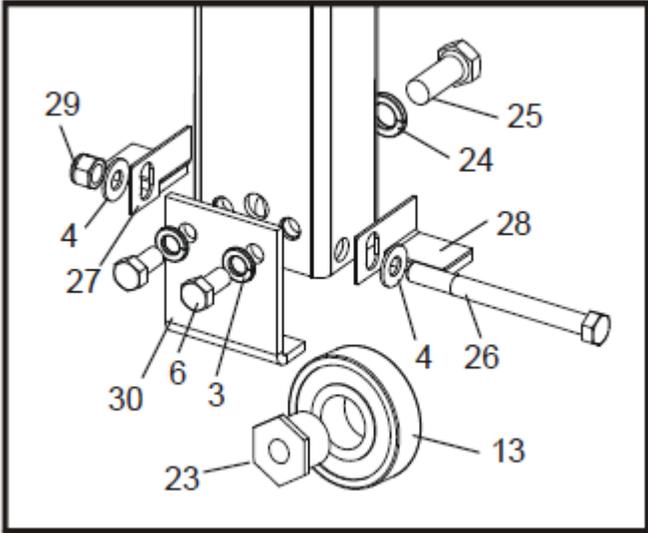
Here is what we had on early revisions. Item 28 was an L bracket with a felt pad glued to it. The pad would come off and the bracket would scrape.

Here is what we use now. Item 28 is a felt pad held in place by item 29 and the item 27 bolt.
